PC.1071A PAGE 3
 REVIEWED BY: [Signature] DATE: 12-3-77
 DOUBLE SCALE
 NO L.A. CO. CHARGE FOR CONNECTIONS
 SEE SAN. DIST. FOR SPECIAL CONNECTION CHARGES

EEBEN SAN TRACT

52625

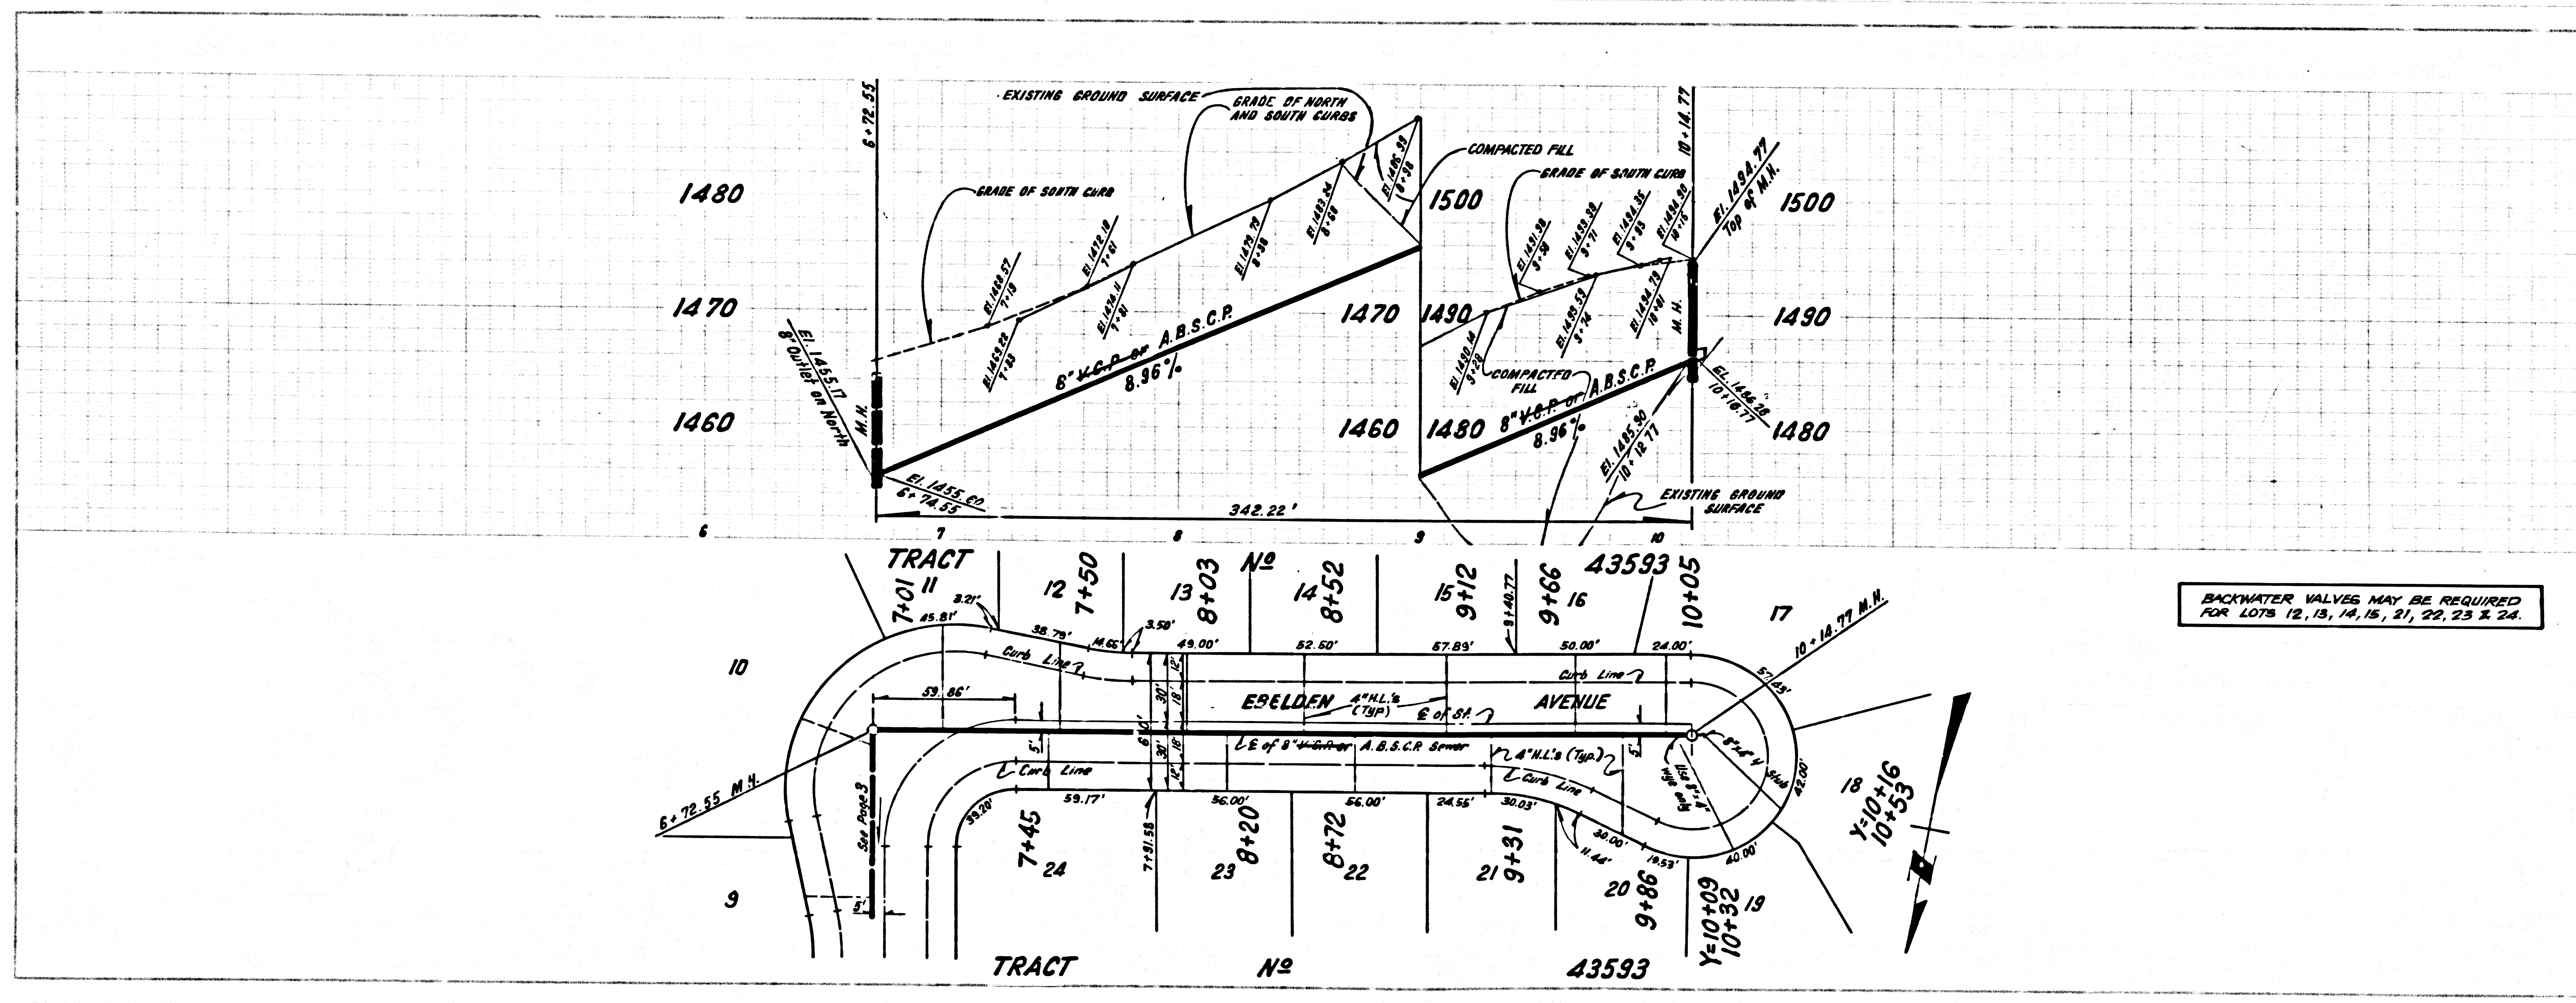
BACKWATER VALVES MAY BE REQUIRED FOR LOTS 1, 2, 3, 4, 6, 7, 8, 9, 10, 11, 25, 26, 27, 28, 29 & 30.

BACKWATER VALVES MAY BE REQUIRED FOR LOTS 12, 13, 14, 15, 21, 22, 23 & 24.
